**Potomac Foods Drive-Thru Conditional Use, CU 17-03**

**Completed: 6/9/17**

- Request for a drive-thru associated with a restaurant;
- Located at 16004 Shady Grove Road, Gaithersburg;
- 1.71 acres zoned GR- 1.5 H- 45, 2010 *Great Seneca Science Corridor Master Plan*;
- Applicant: Potomac Foods Real Estate, LLC.;
- Filing Date: August 10, 2016;
- Public Hearing by the Hearing Examiner: July 7, 2017.

JOB NO.  
37155  
SHEET NO.  
L2.0

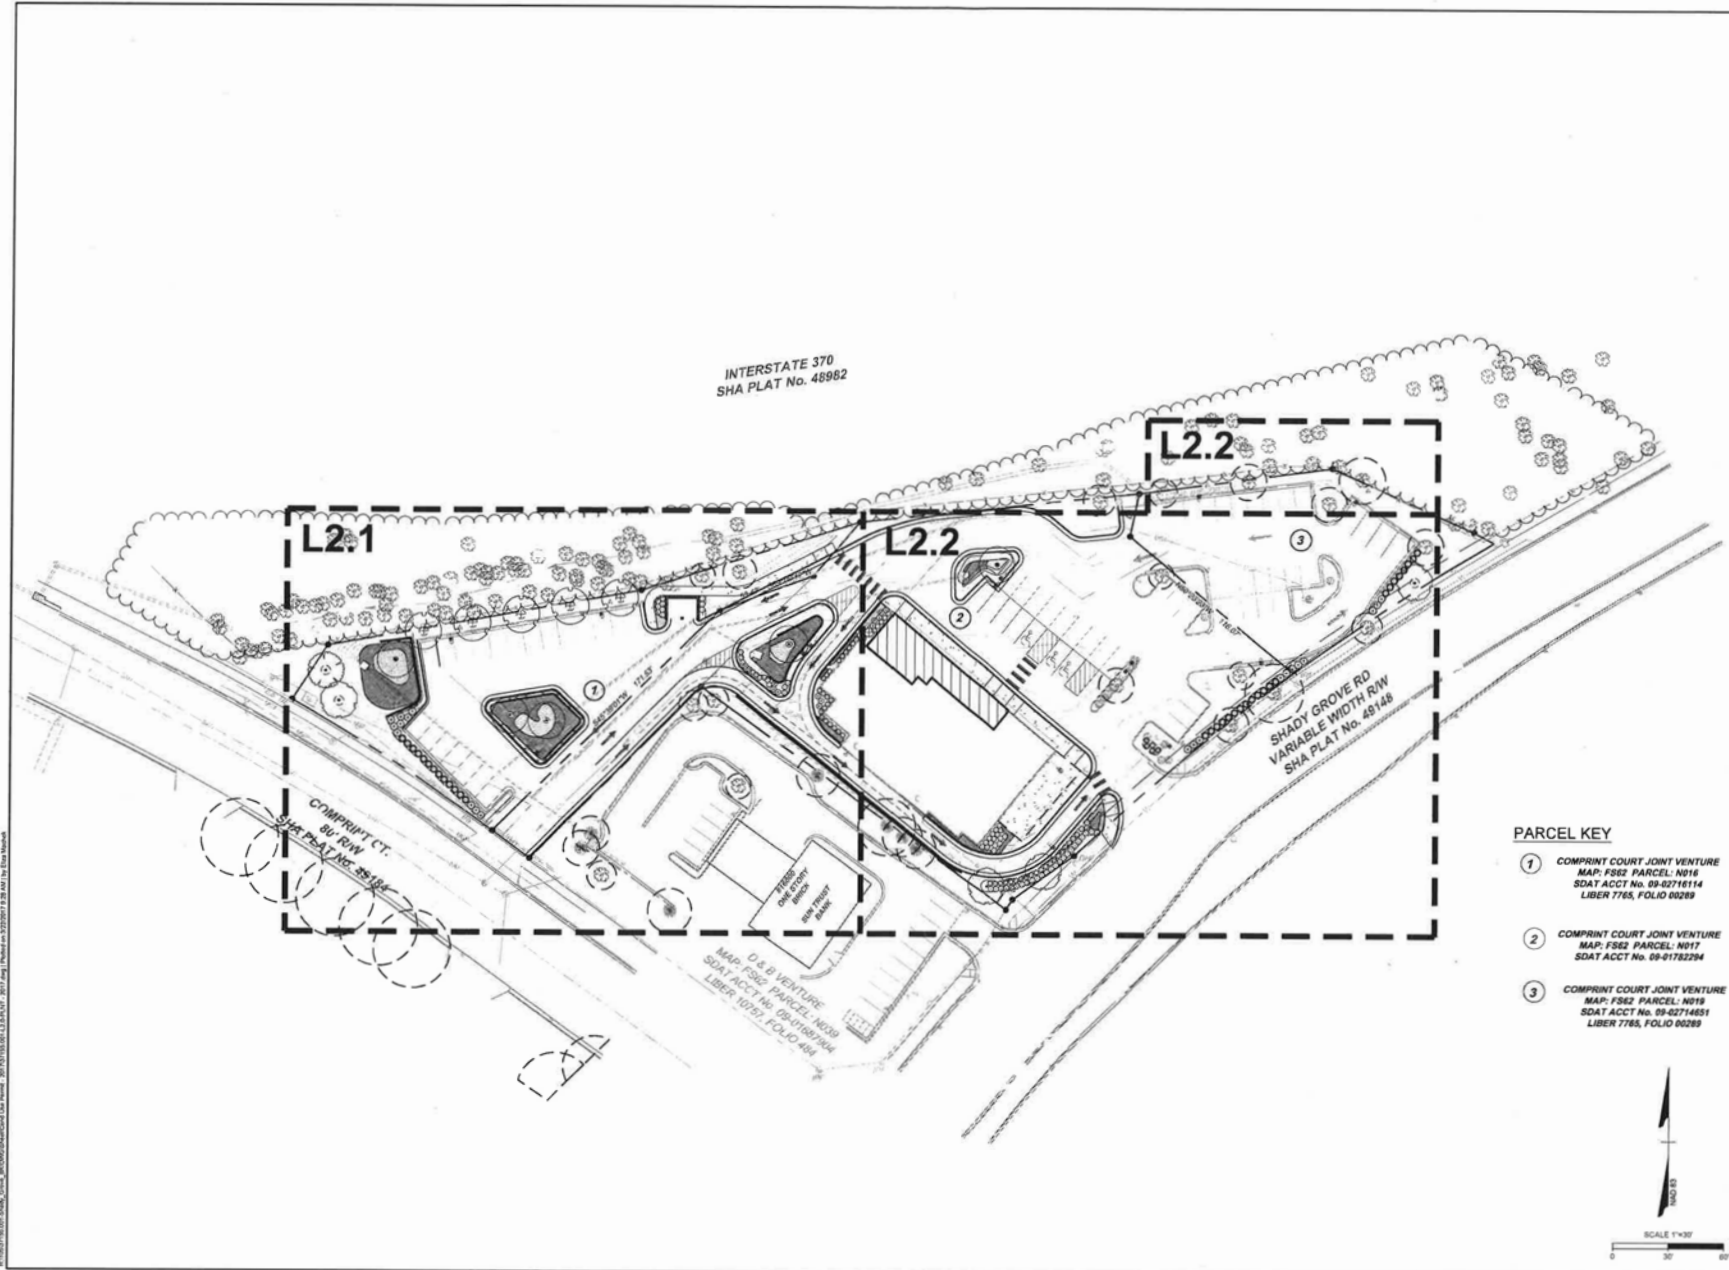
The landscape plan shows that the perimeter of the parking area along Comprint Court and Shady Grove Road will be planted with a mixed evergreen hedge and canopy trees.
